STORYTELLER CAFE ADDITION

CIVIL SITE PLAN
STORYTELLER CAFÉ

C1 .pdf V1 - Changemark Notes (5 Notes)

C2.1 .pdf V1 - Changemark Notes (8 Notes)

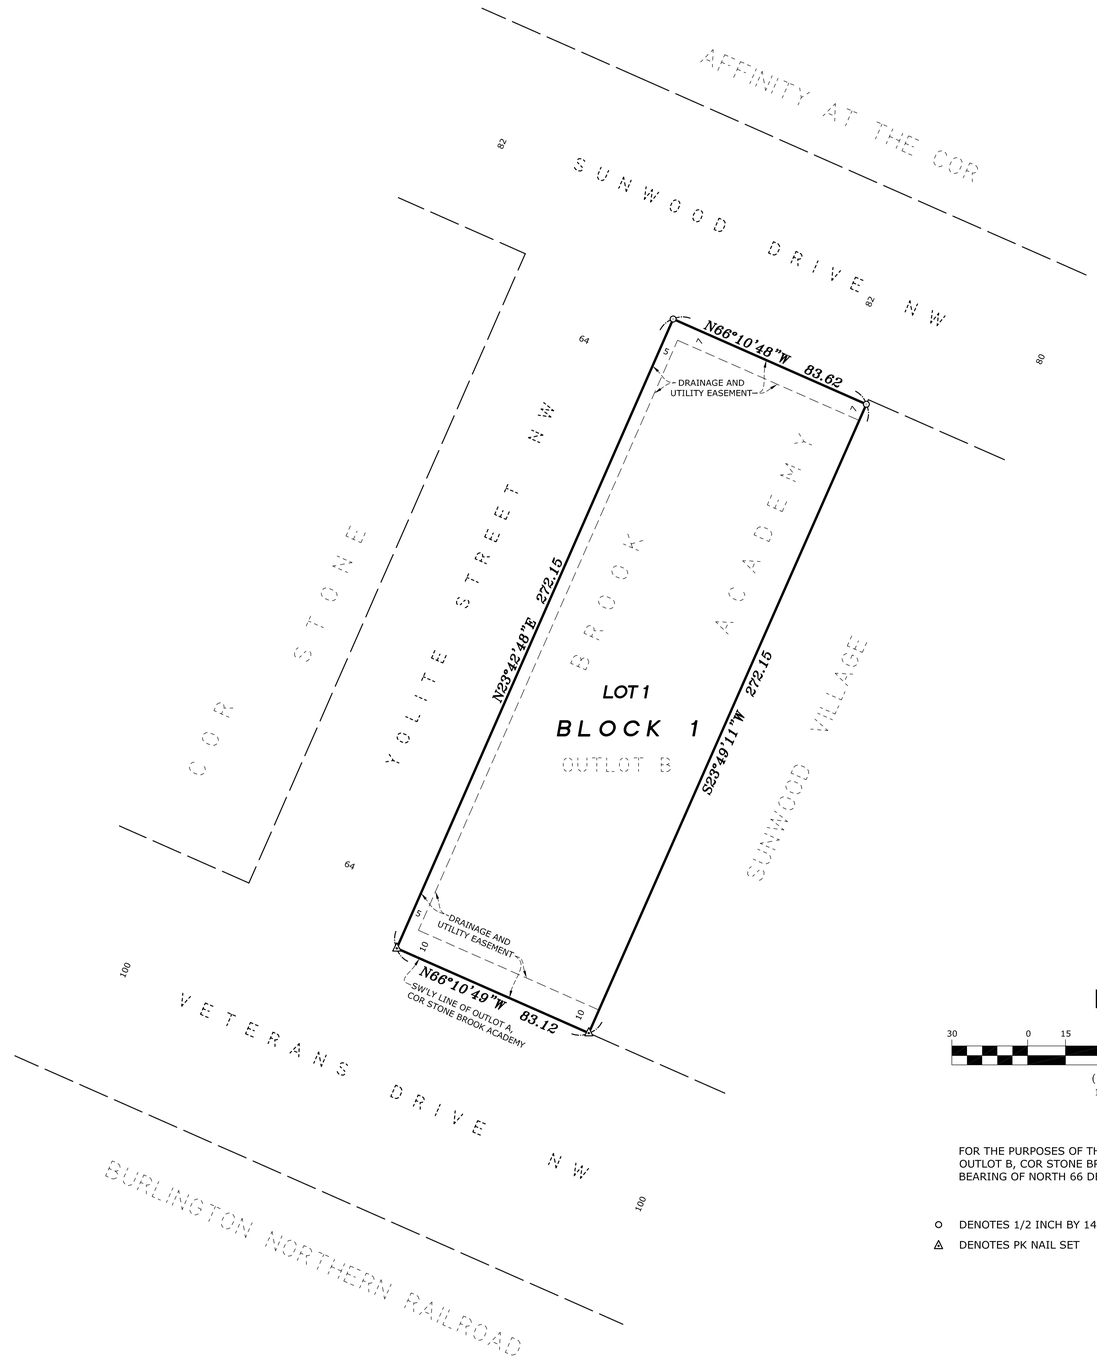
The City doesn't own this lot.

C1

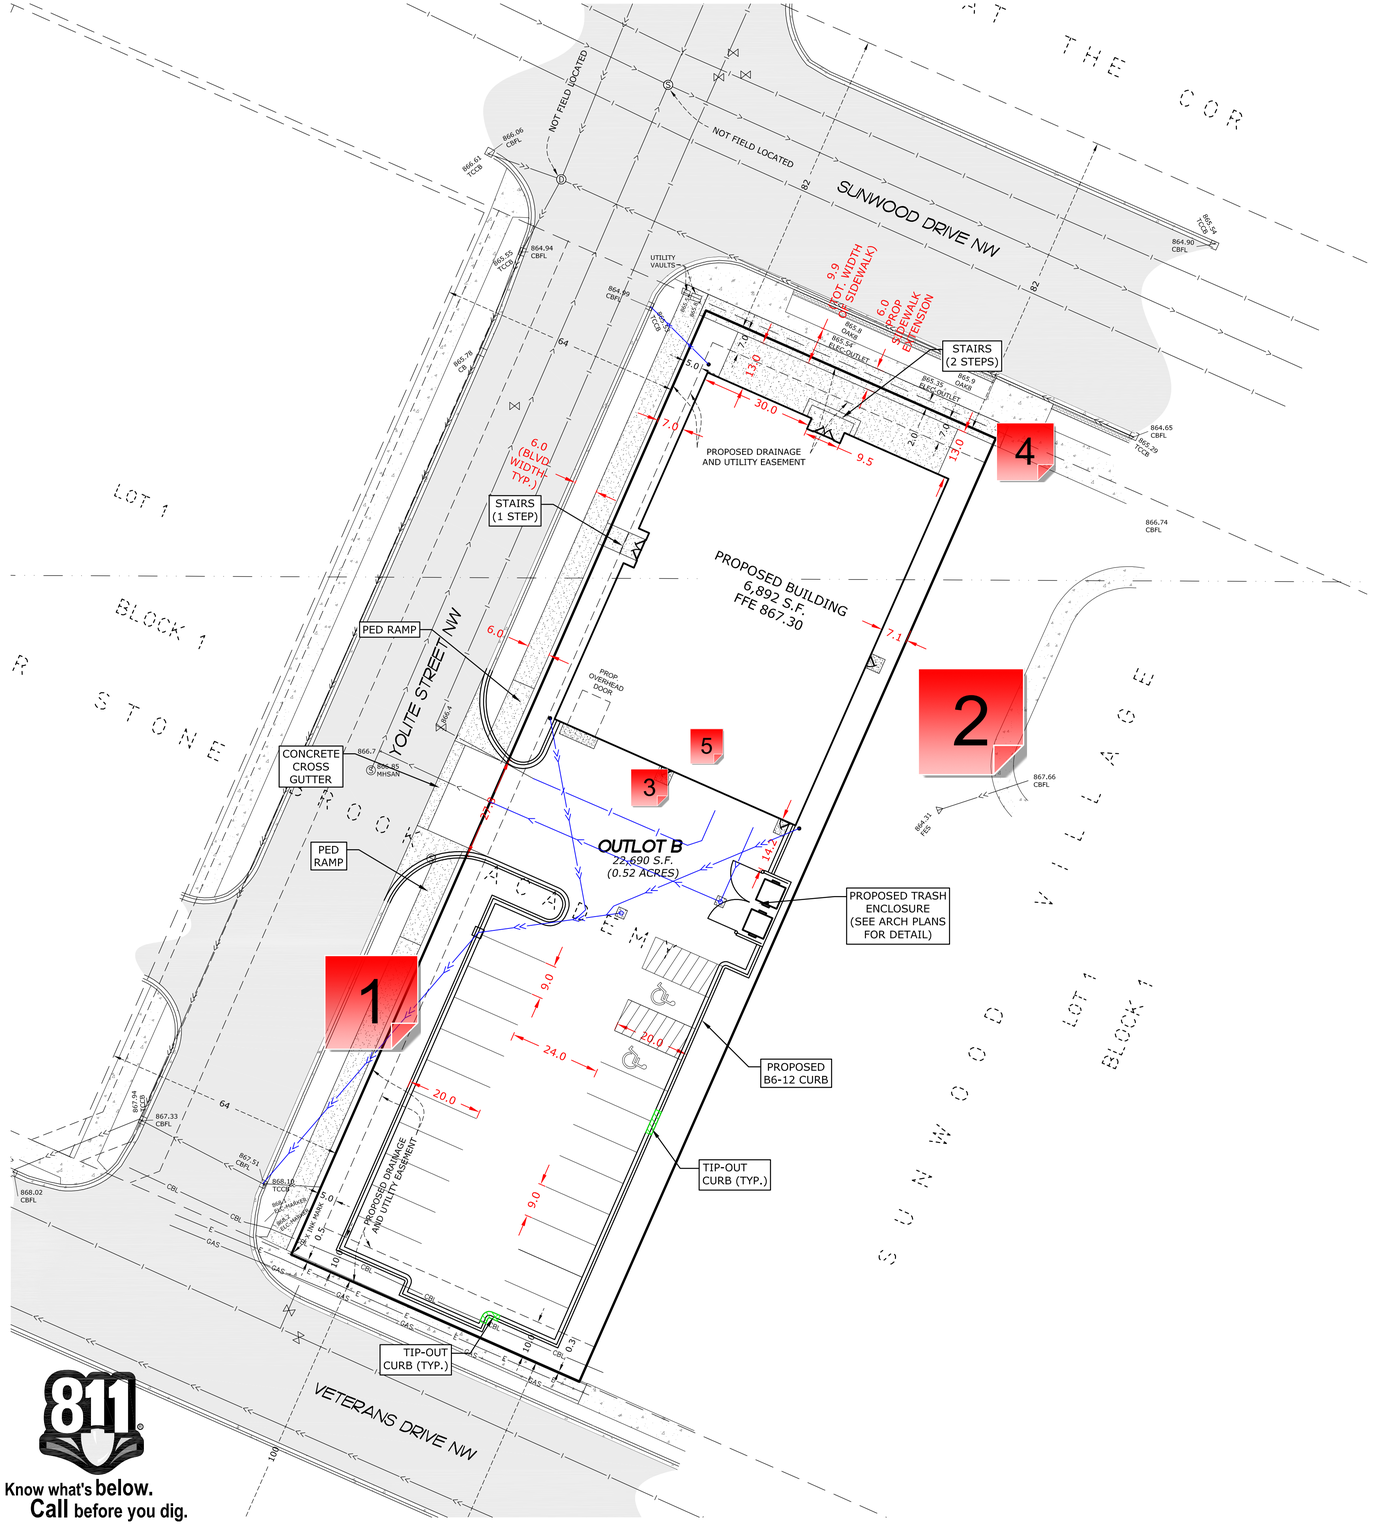
Need to add two (2) 'Cobra' street lights in the boulevard along Yolite Street per the Master Street Light Plan (one north of the access and one near intersection of Yolite and Veterans Drive). Developer will work directly with Connexus Energy for instatllation.

A walkway should be added to connect this exit to either the parking lot or to the sidewalk along Sunwood.

A walkway with B6-12 curb should be provided connecting this 'main' entry point to the sidewalk. This will create some separation between pedestrians and vehicular traffic.

A Sidewalk Encroachment Agreement will need to be executed for the portion of public sidewalk that encroaches onto private property.

A curb has been suggested to provide separation between the parking lot and building. A pedestrian ramp must be proided to allow access to the buiilding.

C2.1

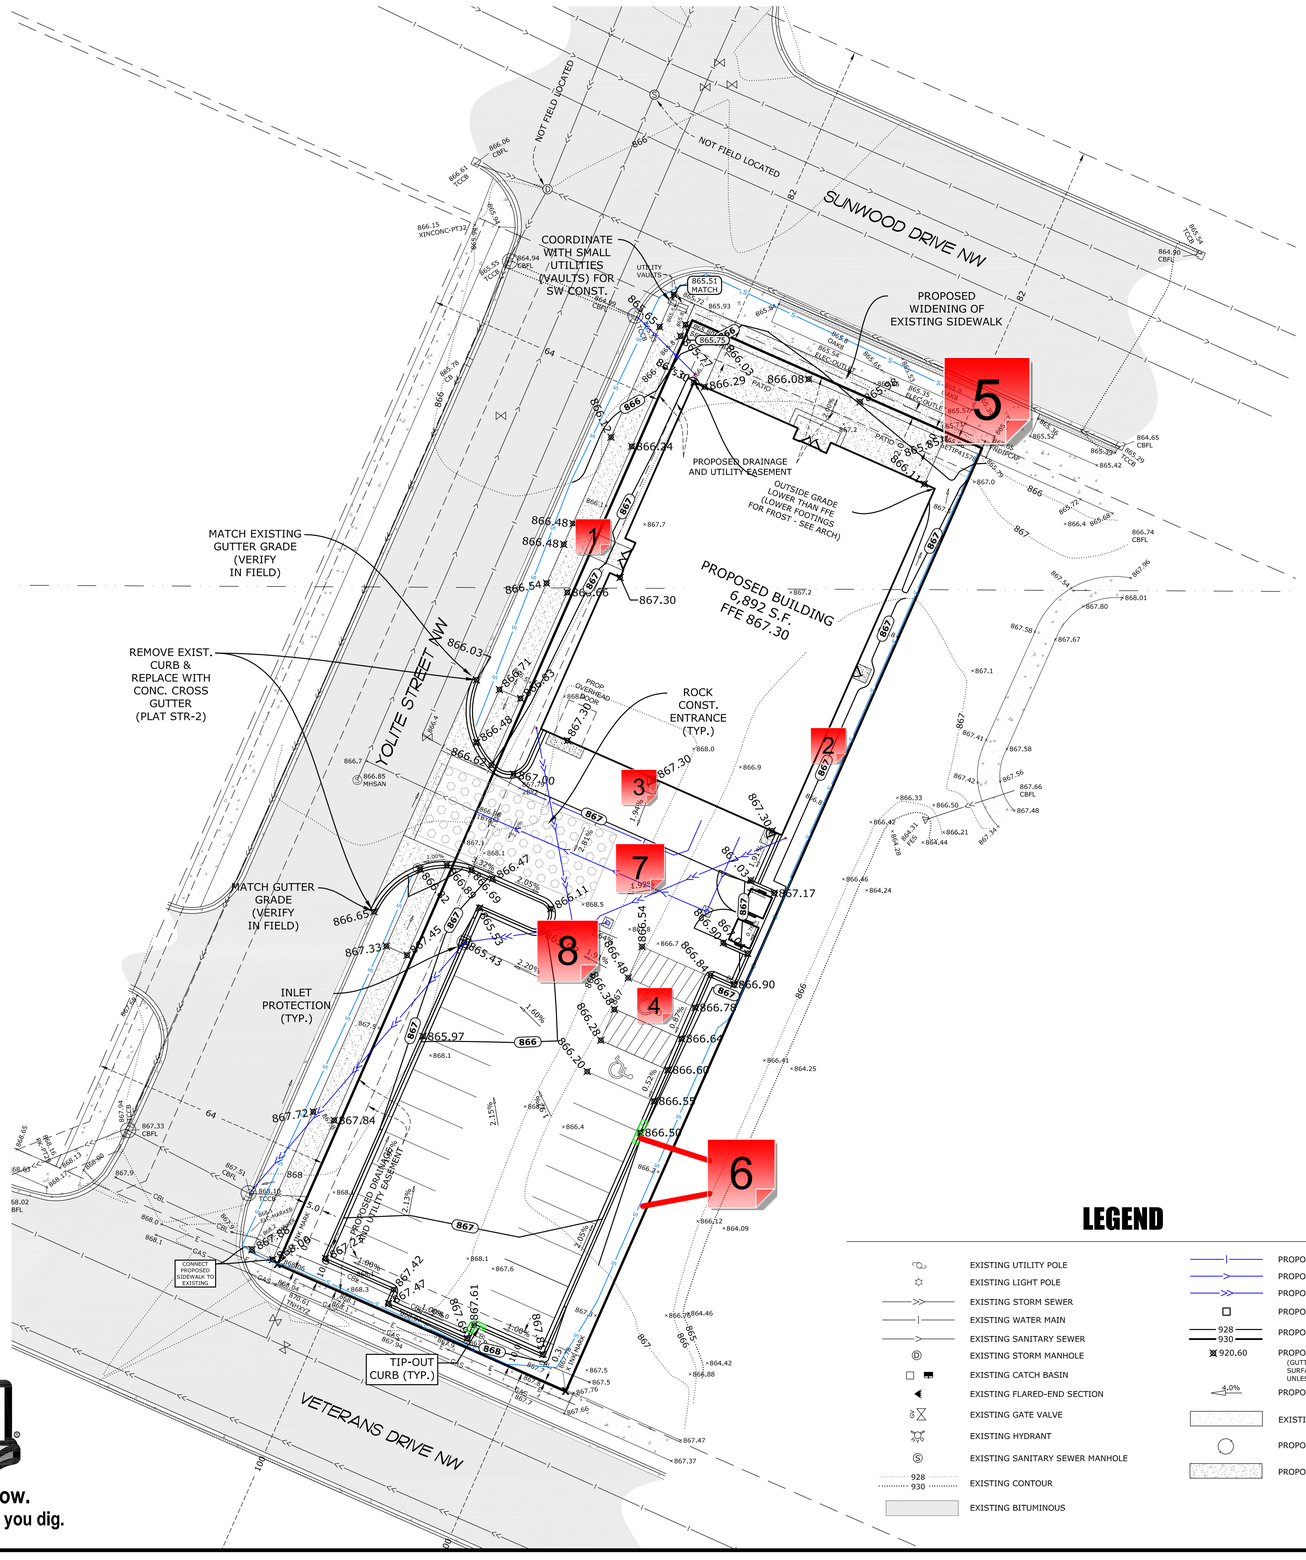
Can we figure out how to make one of these doors handicapped accessible? Perhaps adjust the sidewalk a bit to eliminate the step.

Pave the path from the side door to the public way (parking lot) for emergency egress and for service usage.

As the door from the parking lot, it isn't very welcoming. Perhaps consider a concrete apron around the building foundation and some planter boxes.

Why two access aisles? You can share one for the two spaces. Make sure it is signed properly.

Provide a physical barrier to protect existing streetscape throughout construction.

Add these symbols/line types to the legend.

Grey out line types that aren't relevant to this sheet such as the watermain and sanitary sewer.

Storm Sewer lines must join in structures,not Wyes buried under pavement.

C2.2

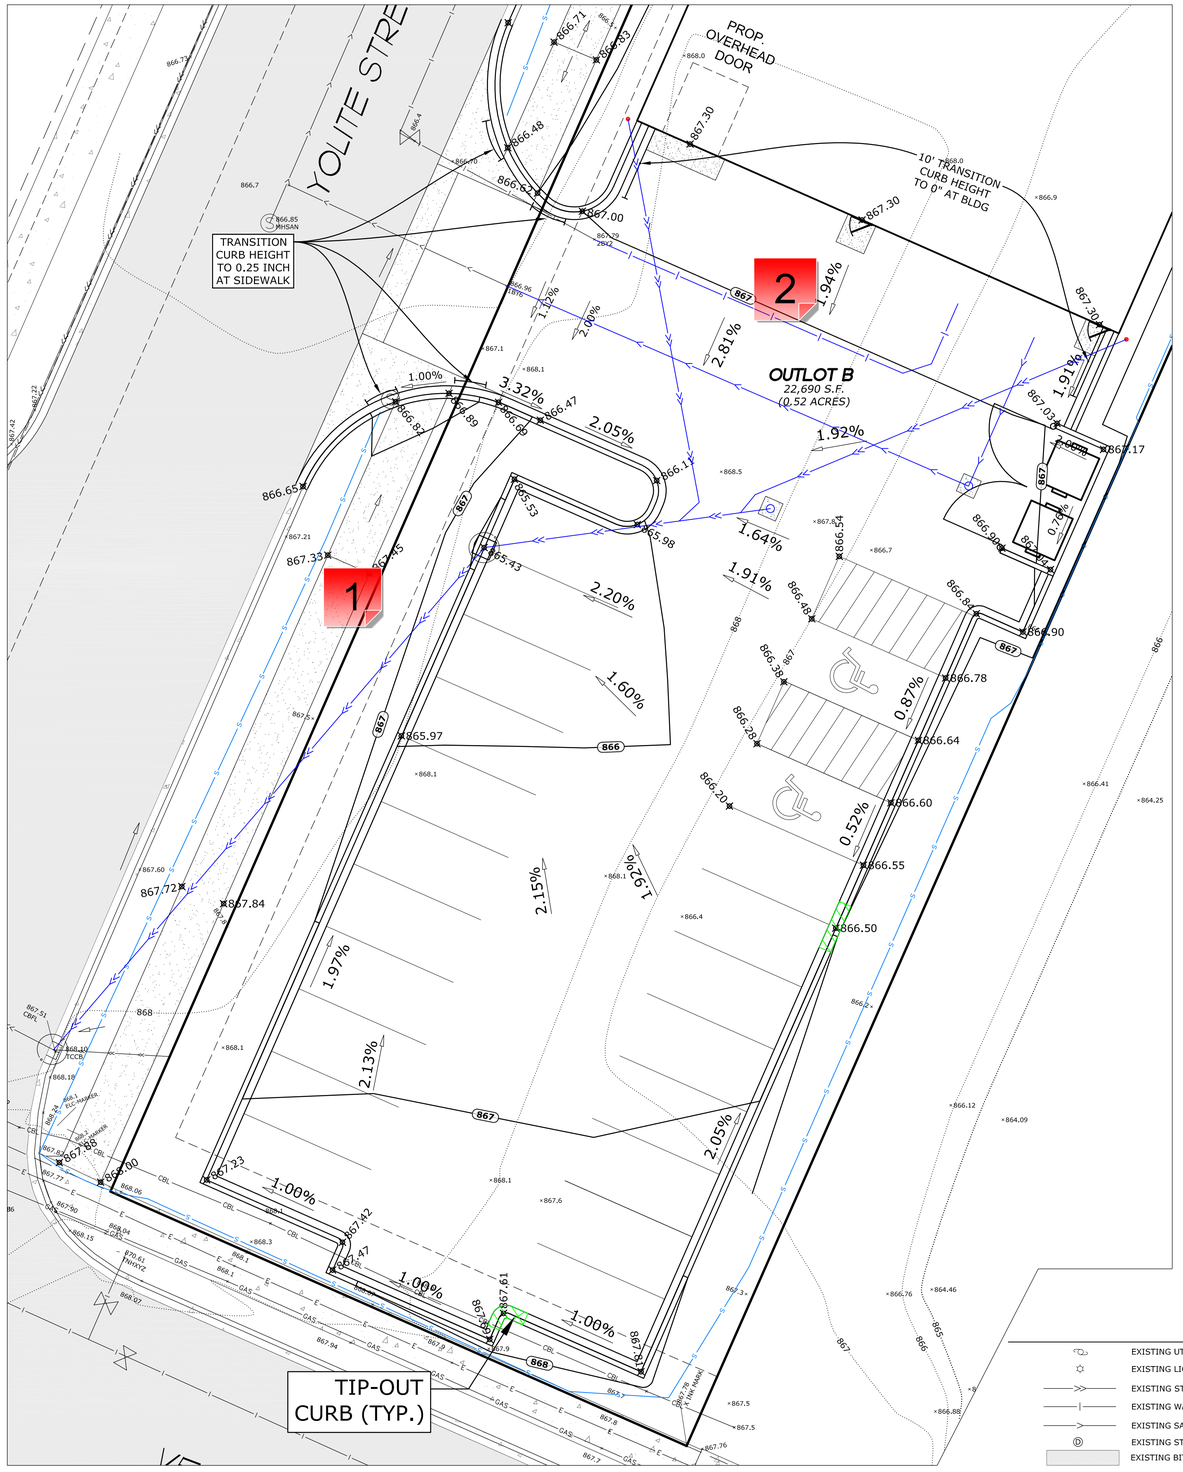
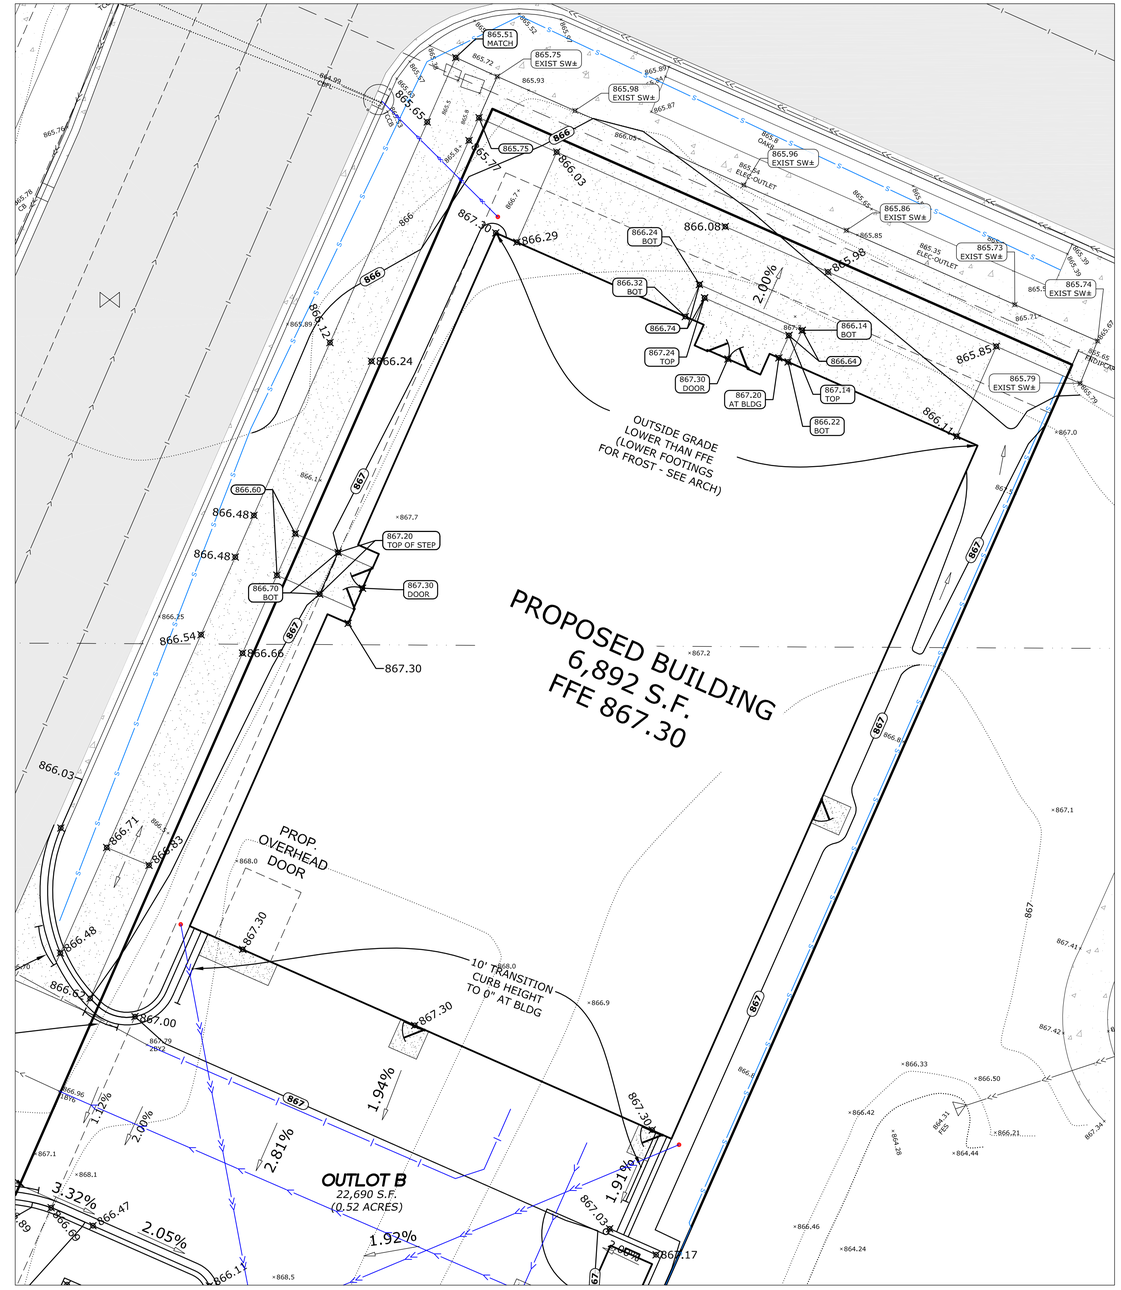
There are no pipe sizes or types on any sheets

Grey out line types that aren't relevant to this sheet such as the watermain and sanitary sewer.

C3

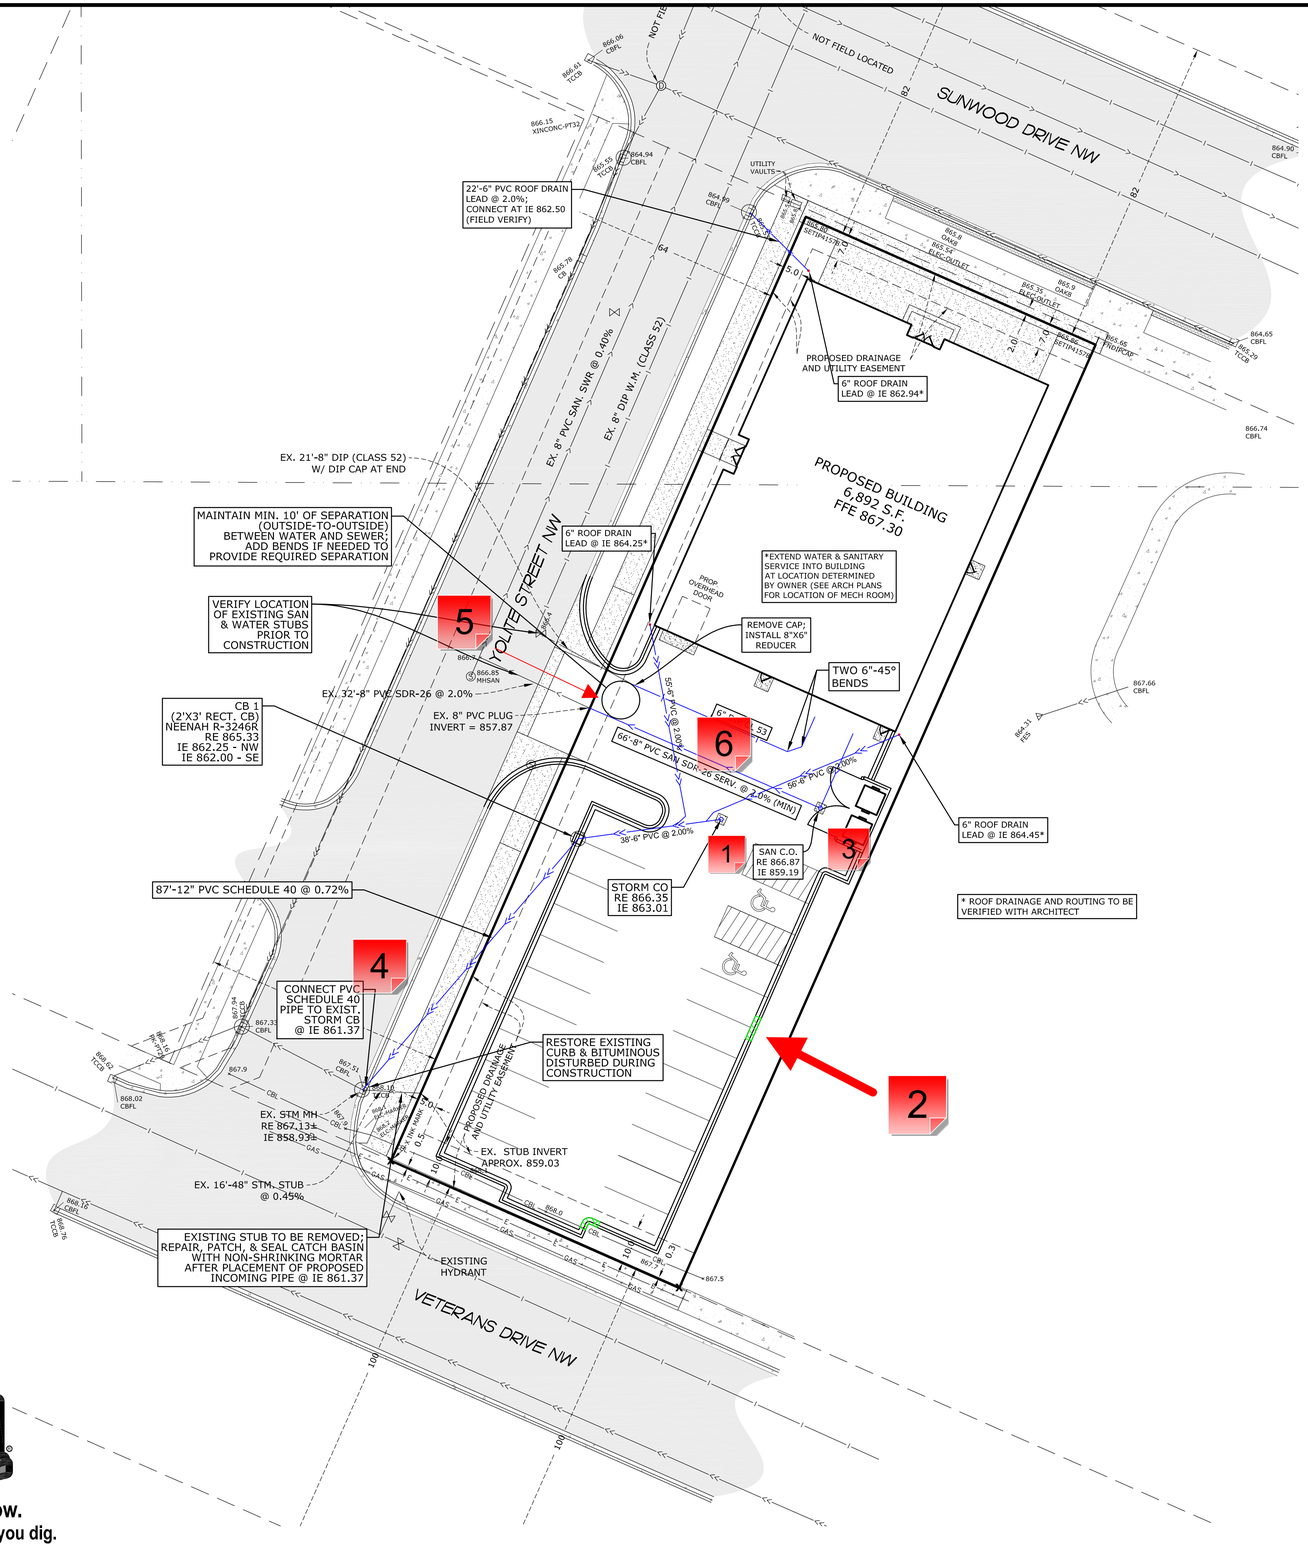
Is there a reason not to run the roof drains directly into a structure instead of connecting to pipe with wyes in the middle of the parking lot? This way cleanouts could be located near the building instead.

Add all line types shown to legend or remove from sheet if they aren't relevant

Cleanout is shown at 90 degree bend. Show in detail how this is to be accomplished or else add in 45 deg bends.

Revise storm sewer routing to utilize existing stub. There is not wall space to add connection as proposed into existing catchbasin.

This appears to be a drafting aid. Remove circle from plan.

A cleanout is required upstream of every bend in PVC pipes. Simplify storm sewer layout to remove bends.
